T ECHNICAL INFORMATION

- Subject** ▶ Elimination of a Flat Washer 16 and Change of Cam Housing Complete
- For Models** ▶ HP2030, HP2031
- Country** ▶ All countries
- Description** ▶ 1) One of the two "Flat Washers 16" placed around Armature has been eliminated.
 2) Cam Housing Complete has been modified as described below.
 (Note) Item Nos. in the illustration are those of Parts Lists.

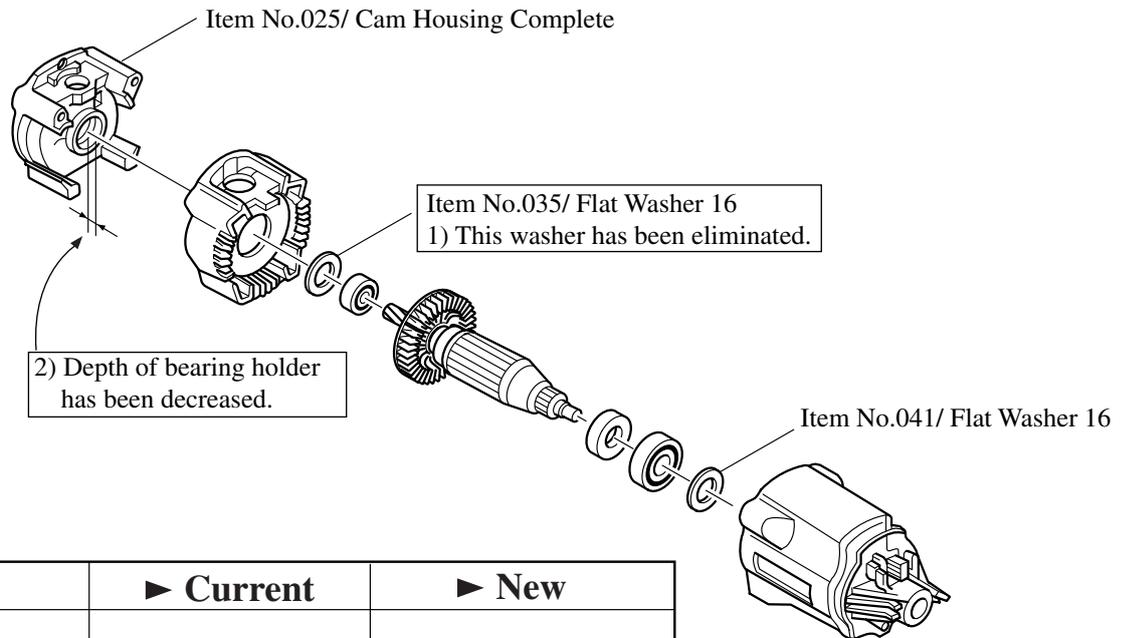
| | ▶ Current | ▶ New |
|--------------------------------------|---|---|
| Flat Washer 16 (Part No.253707-9) | Item No.035 and 041 | Item No.041 only |
| Cam Housing Complete | Depth of bearing holder : 7.5mm (Part No.159793-7) | Depth of bearing holder : 7.0mm (Part No.151764-0) |

| Item No. | Current part | Q'ty | I/C | New part | Q'ty | Note |
|--------------------------------------|----------------------------------|------|-----|----------------------------------|------|--|
| HP2030: 035, 041 HP2031: 035, 041 | Flat Washer 16 253707-9 | 2 | Yes | Flat Washer 16 253707-9 | 1 | The Flat Washer 16 of Item No.035 has been eliminated. |
| HP2030: 025 HP2031: 025 | Cam Housing Complete 159793-7 | 1 | No | Cam Housing Complete 151764-0 | 1 | |

When replacing the Current Cam Housing Complete by the New Complete, always remove the Flat Washer 16 on the side of Fan of Armature (Item No.035 in Parts List).
